HISTORIC PRESERVATION BOARD

AGENDA

TO: Members of the Historic Preservation Board
FROM: Rob Wiener, Preservation Compliance Coordinator
DATE: August 28, 2020
RE: September 2, 2020 **PUBLIC HEARING – Amendment to Previous
Approved Alterations: Three Additional Skylights**

On behalf of the new owner of 446 Fore Street, Orange Crush, LLC, Architect Jake Keeler has requested a Certificate of Appropriateness for façade alterations to the 53 Wharf Street façade, and the adjacent Union Street face. In 2019 the Board approved a comprehensive exterior renovation program for the upper floors of the building, which did not include the commercial space on the ground floor facing Fore Street or the basement level facing Wharf Street. Since that review took place the building was sold, and the new owner is continuing the renovations based on the 2019 plans, with Jake Keeler Design Build managing the project.

153 State Street, Google Earth

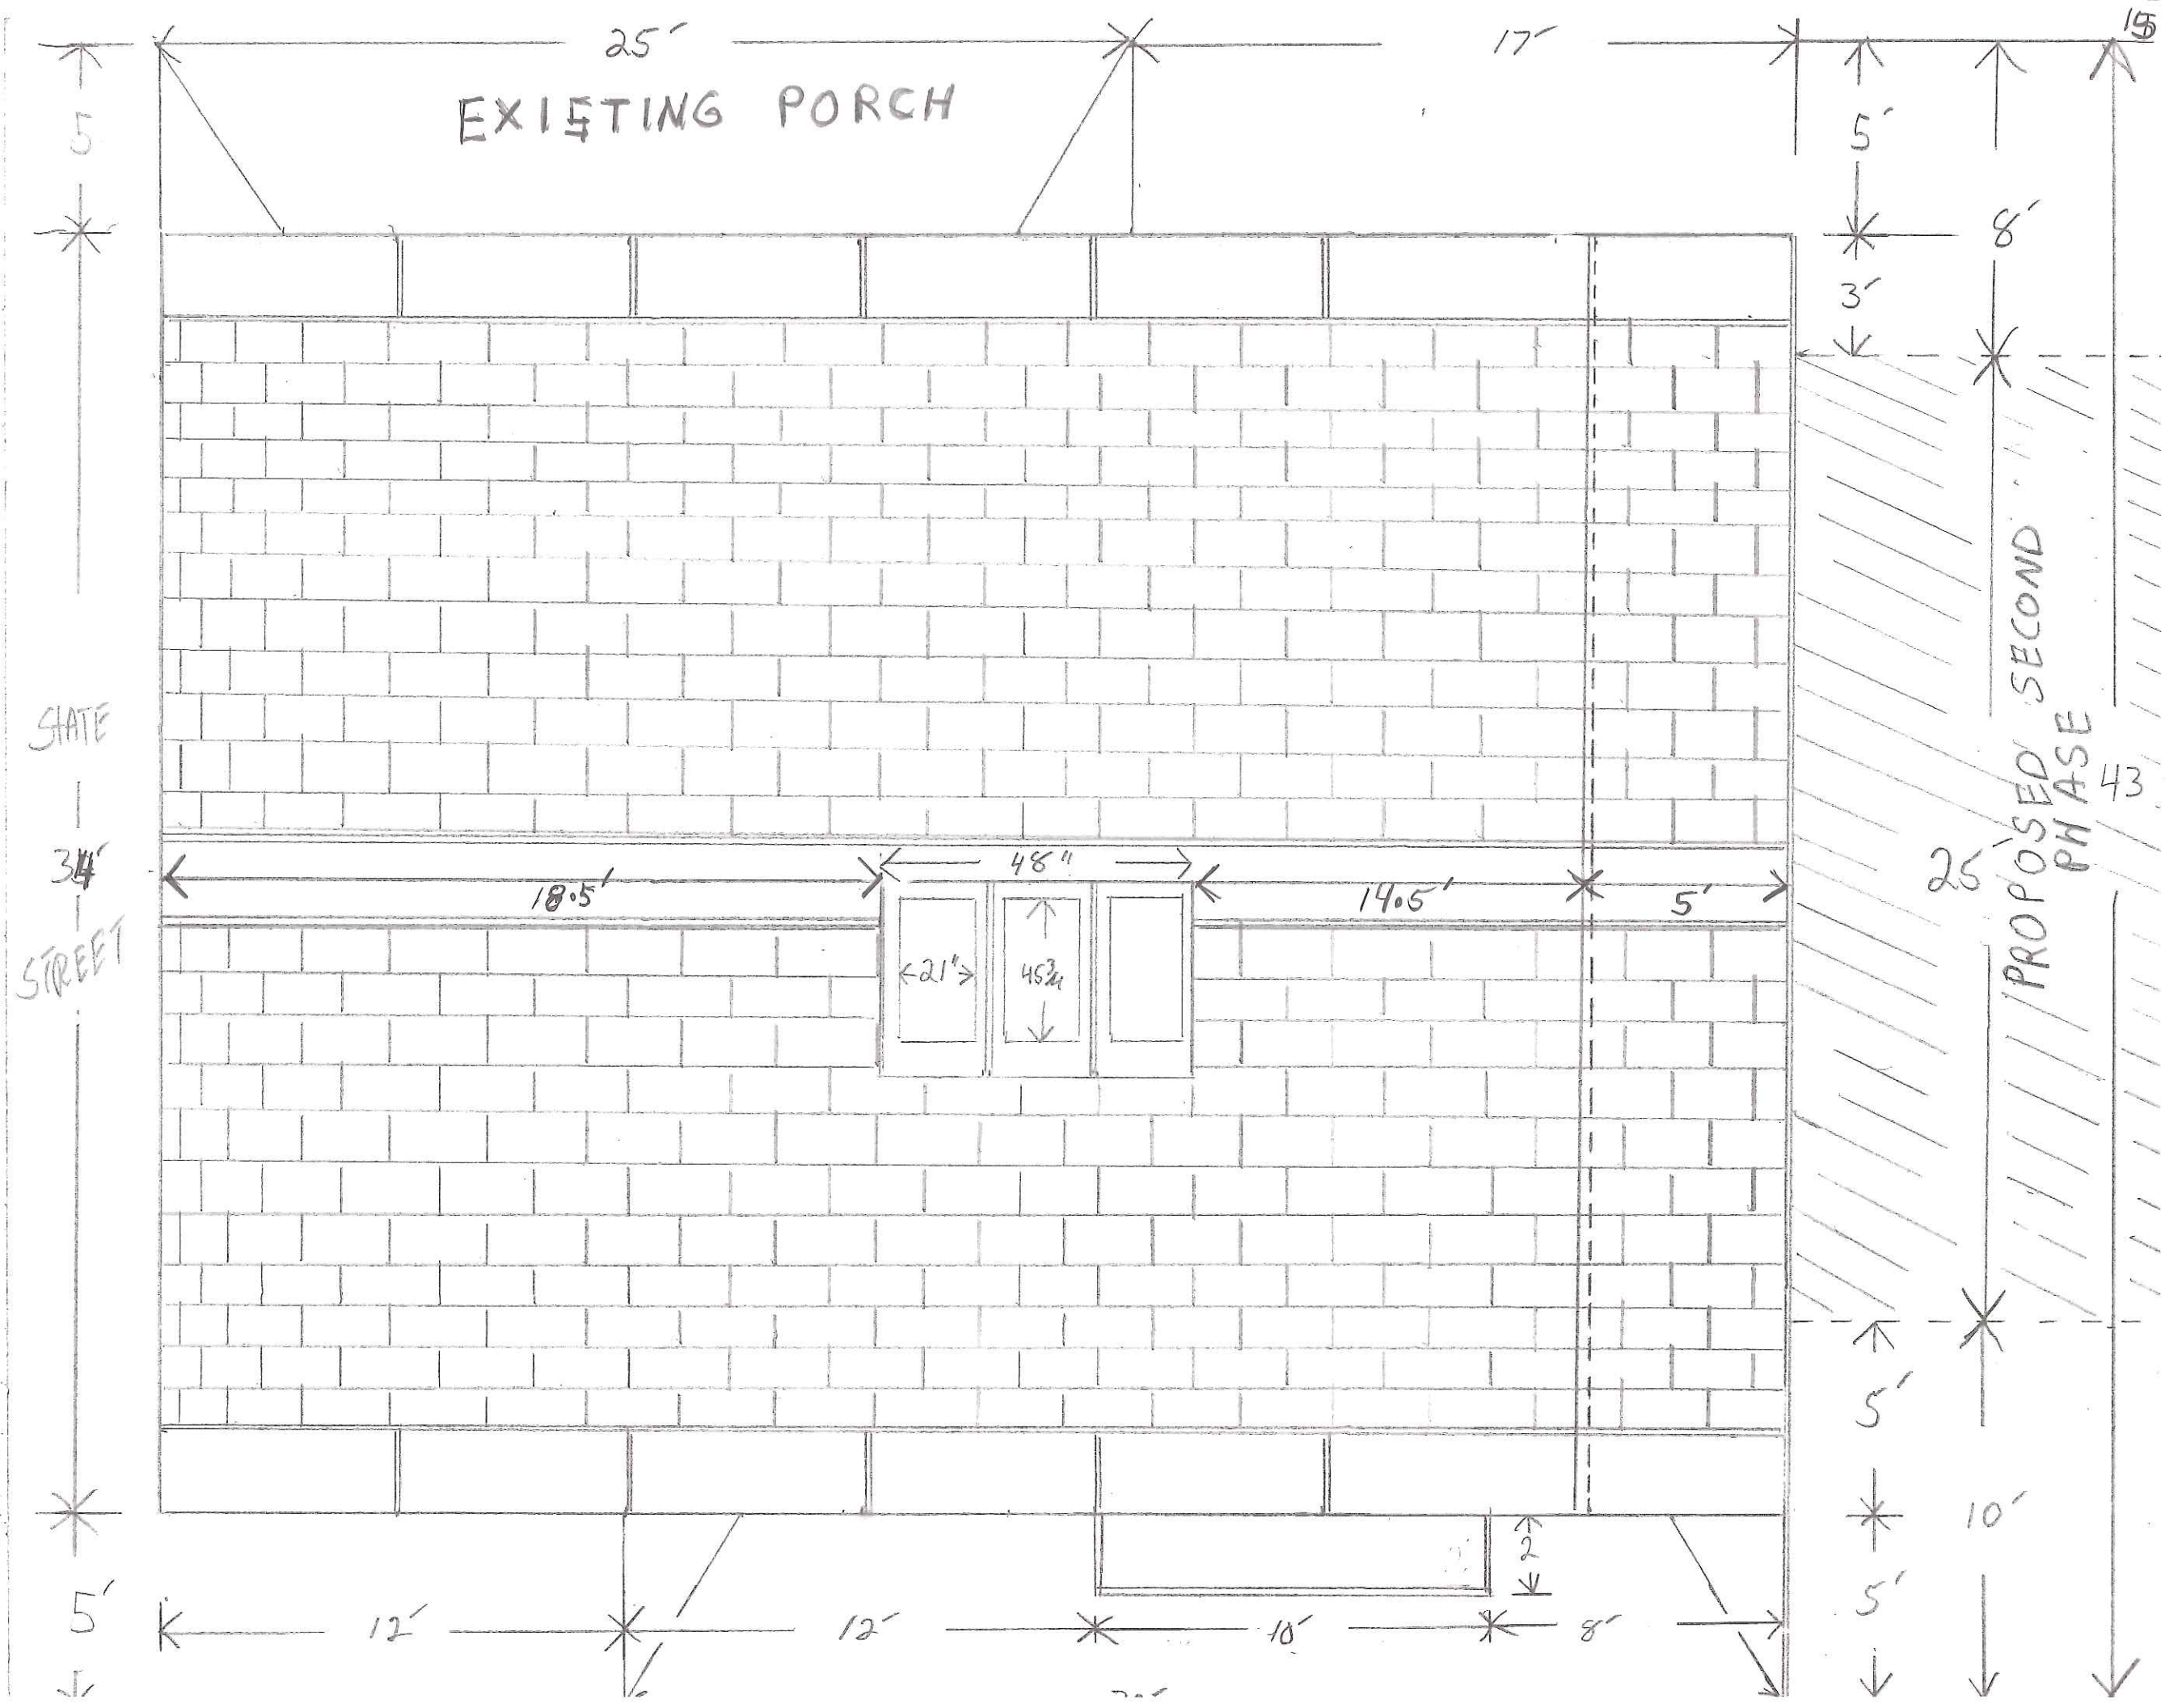
The existence of an older, domed skylight on the south roof provided a starting point for a replacement unit, and two more arrayed next to it, moving toward the rear. In the case of the currently proposed units on the north roof, the roof has no existing skylights. The proposed north units are located in the front half of the roof, with the closest one to the street being about 11' from the front rake. As can be seen in the supplied staff photo, the north skylights would be visible from State Street and the sidewalk, until one is close enough to the subject property for them to be obscured by the roof and the upwardly angled line of sight.

Because of the significance of the subject property and the proposed location facing a notable historic church, staff believes it would be preferable to locate the skylights on the rear half of the roof, but the location of an interior wall limits how far toward the rear the units can be located. Staff was concerned about the likely visibility of the north skylights from State Street, and did not view this proposed amendment as a de minimus change to approved plans.

In conversations with staff, Mr. St. Peter has indicated the possibility of some flexibility in his proposal for north and south skylights, but clearly would like to add as much light and view of the church on the north as possible. Thus the applicant favors having all three of the north units, particularly the one closest to the front. Skylights have been approved on historic roofs many times, but locations that minimize the visibility, particularly those distanced from sensitive, prominent faces, have usually been heavily favored.

DRAWING NO:
A2.2

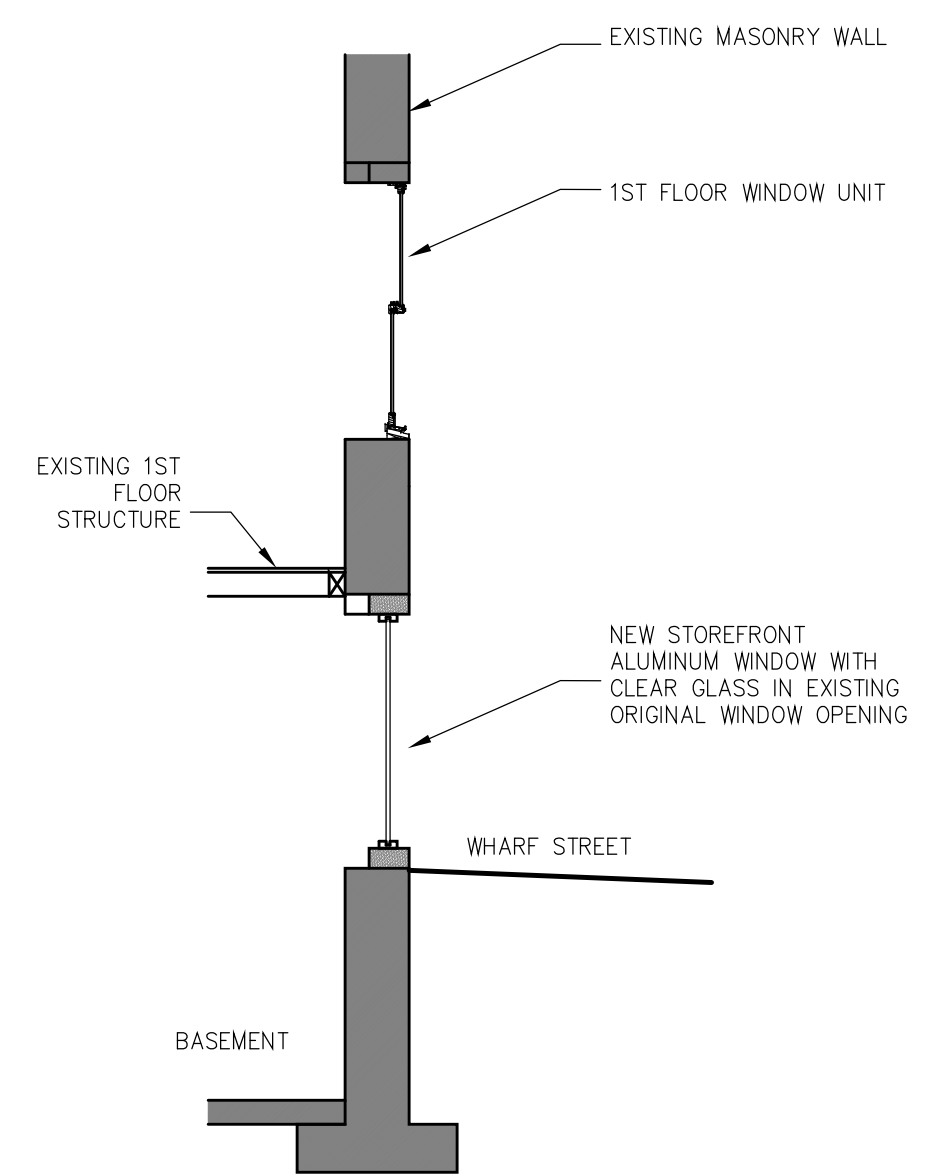
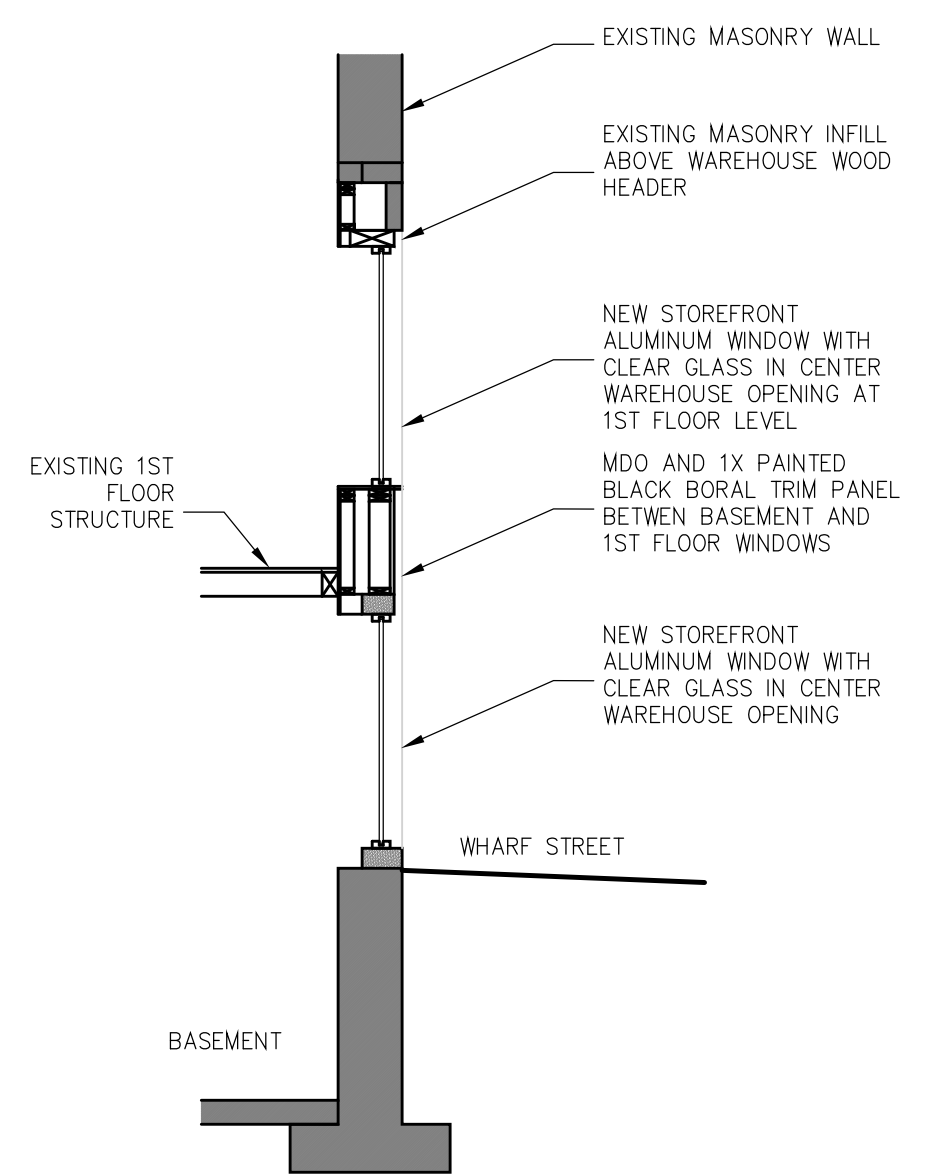
There exist several possible approaches to the center openings on Wharf Street, and staff notes a number of questions and considerations:

- The existing center door is not set back in the masonry opening, creating an awkward relationship with the freight door panel above it. A final set of detailed plans will have to show the relationships of doors and windows to the face of the masonry.

At the western window opening facing Wharf Street, the photos show that it has been altered so the CMU infill no longer lines up with the still present granite lintel. The elevations do not make clear exactly how the restored opening will be recreated, except that it appears to be centered under the windows above. Staff suggests that if the granite lintel is evidence of the original building or a significant acquired detail, it should be retained and reused.

In recent years, the trend in lighting on Wharf Street has been gooseneck, hooded fixtures similar to those proposed by Mr. Keeler. Unfortunately, despite attempts by HP staff to keep walls clean, electricians have installed some lamps on other buildings using exposed conduit, excusing the practice by asserting that interior spaces are finished, limiting access to exterior walls, or stating that the number of holes in the brick wall is being kept to a minimum. Staff has also at times questioned the number of fixtures deployed, encouraging only the lighting of doors and signs, and not the street or building façade. Mr. Keeler has assured staff that new fixtures at the basement level of 446 Fore can be fed from inside, and exposed wiring or conduit will not be seen on the exterior walls.
